Title: TX-DS989

Application: Service Tip

Main Micro-processor Section

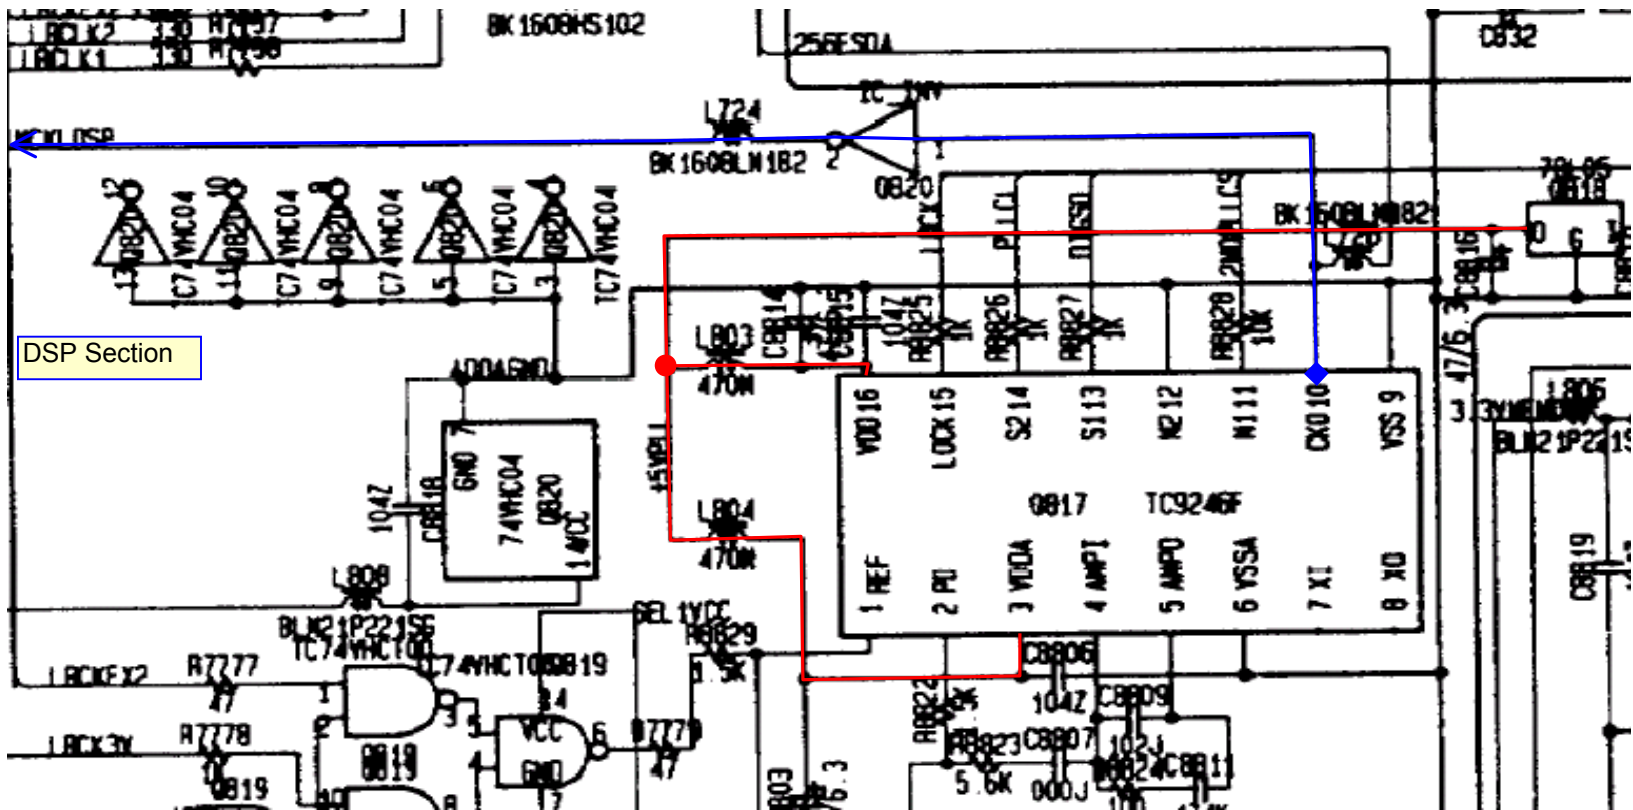
Do to aging an environment (warm) in which a unit may be working, some units may experience power supply failure as a result of cold solder point around Q9203 legs on Main Micro Processor PCB (NAAR-6837-1), Q9302, Q9322, Q9304 and 9303 on Power supply regulator PCB.

A loose connection at Q9203 is known to cause Poor Video, Distorted Audio and malfunction of Q817, Q820 having direct relation to the DSP master clock error.

The failure of this section of the DSP is very critical and that the reproduction experience as stated by a consumer can differ from one customer to the next. Therefore it is very important that one makes all the appropriate touchups on all regulator components and inter connecting wires in the case of NCPS-6839 and NCPS-6838 power supply PCB's.
